MONTGOMERY COUNTY HISTORIC PRESERVATION COMMISSION STAFF REPORT

Address:	8013 Westover Rd., Bethesda	Meeting Date:	10/23/2019
Resource:	Non-Contributing Resource Greenwich Forest Historic District	Report Date:	10/16/2019
Applicant:	Adrienne and Neil Deshmukh	Public Notice:	10/9/2019
Review:	HAWP	Tax Credit:	n/a
Case Number:	35/165-19E	Staff:	Dan Bruechert
PROPOSAL:	Building Addition and Tree Removal

Site Plan

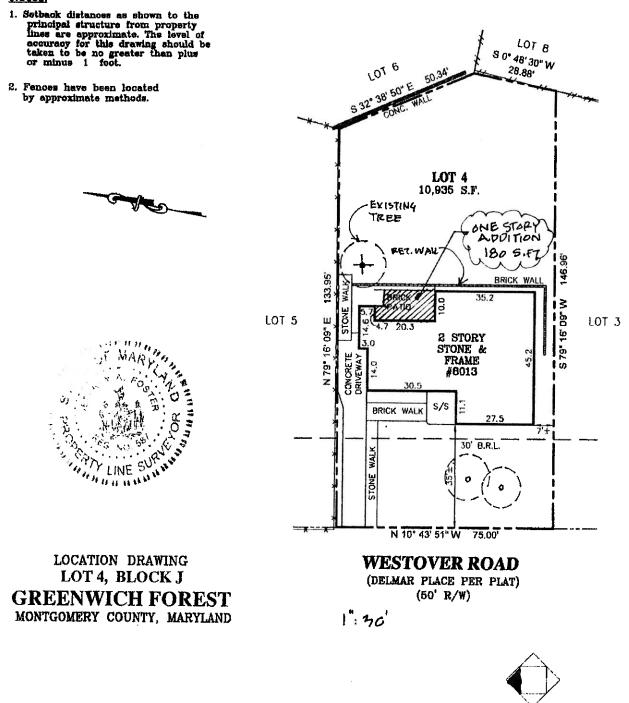
First, there is no information regarding the construction, condition, or appearance of the existing wall (aside from the fact that it's 44" (forty-four inches tall). The site plan shows an outline of a retaining wall and identifies the material as brick, but no other information was provided to evaluate the appropriateness of the work proposed for the wall.

- Photos of the existing wall, both in context and of details showing the condition of the wall;
- A narrative of the work proposed detailing the construction method of the existing and new wall;
- Elevation and section drawings of the proposed wall; and
- Any other information requested by the HPC.

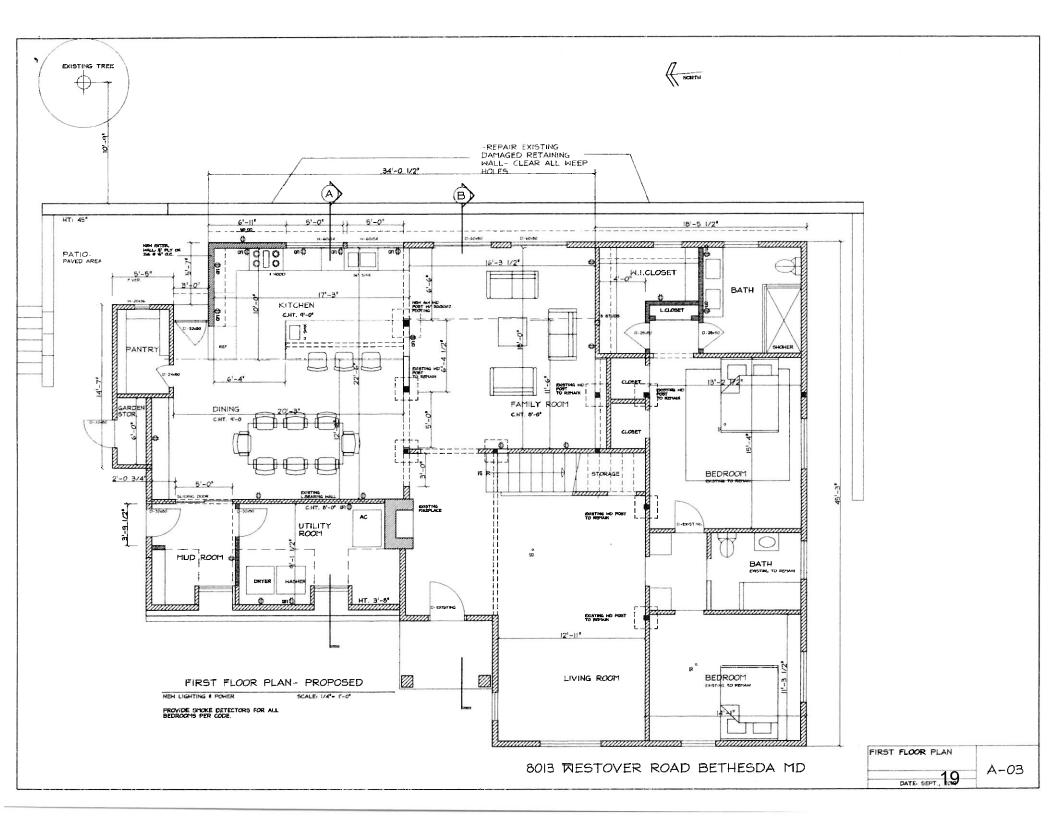
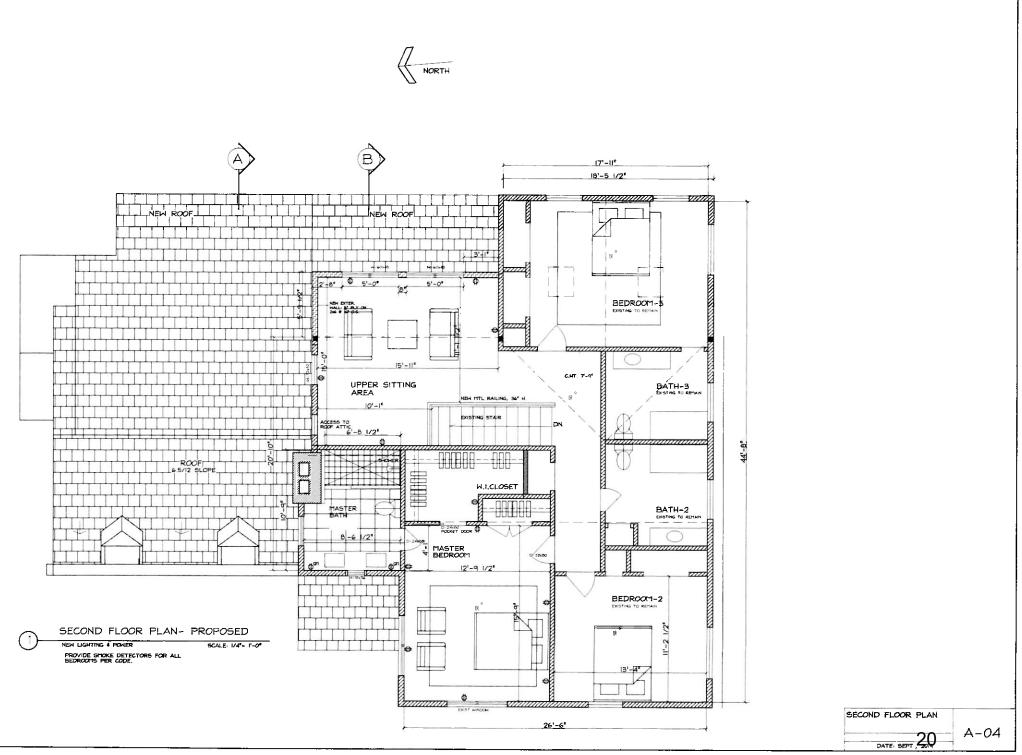
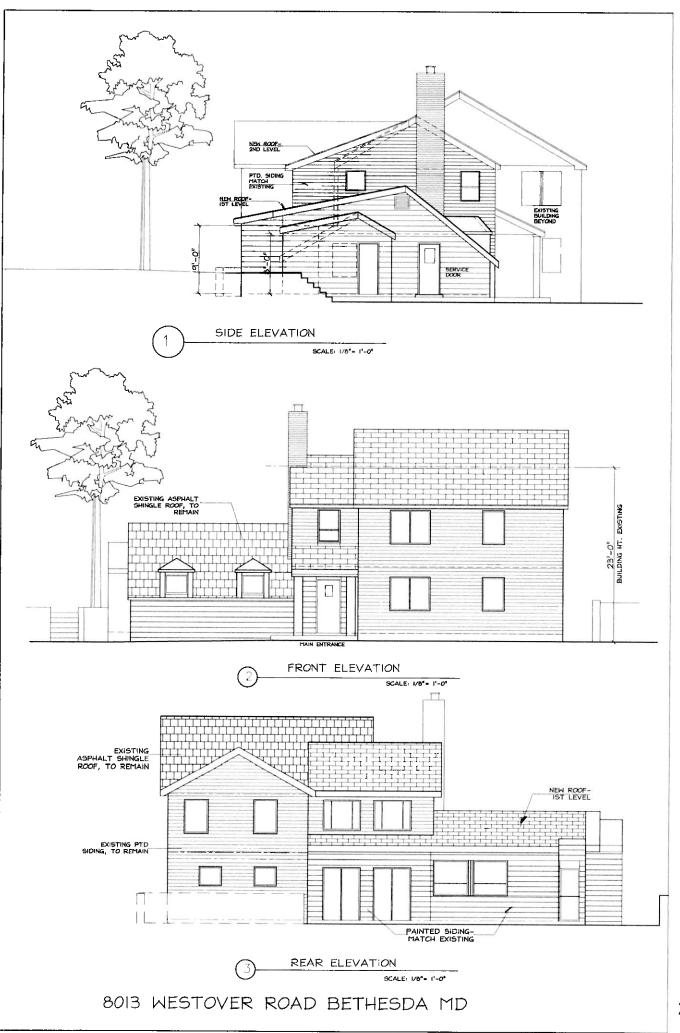
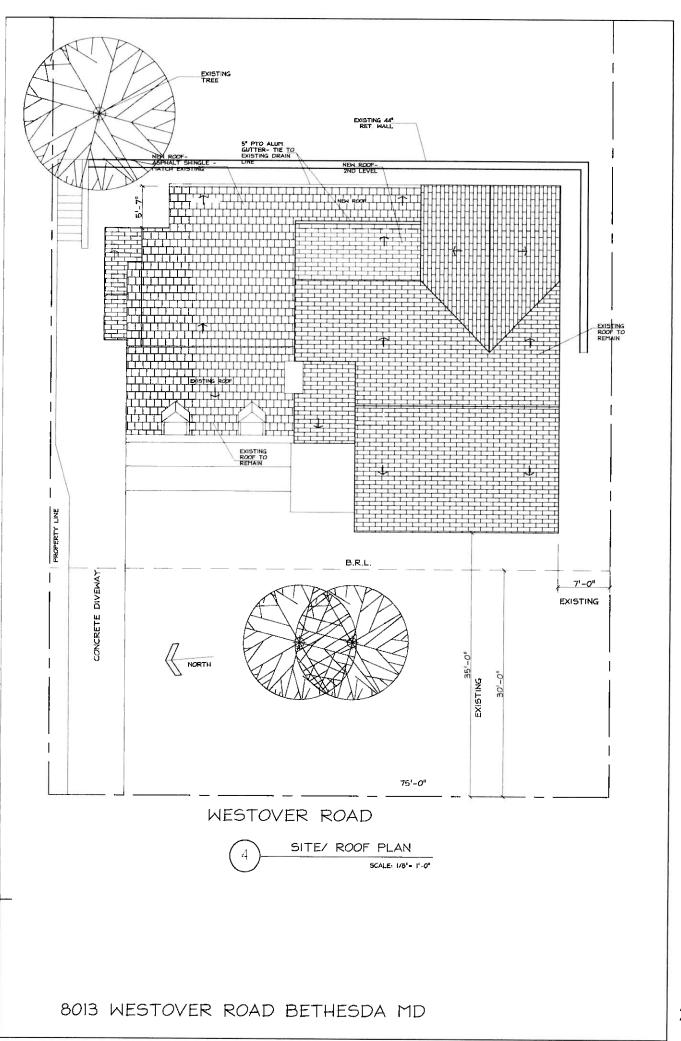
Second, the application materials present contradictory information. The floor plan drawings note: "repair existing damaged retaining wall – clear all weep holes." However, the rear elevation drawings states: "existing wall to be removed." As this work is at the rear and away from this non-contributing resource, Staff would likely support either proposal, but in order to carry out the required analysis a single proposal needs to be presented.

Staff recommends any approval of this HAWP not extend to the removal of the Tulip Poplar or work on the retaining wall. A revised HAWP application should be submitted to directly to Staff for hearing at a future date and should include at a minimum the following:
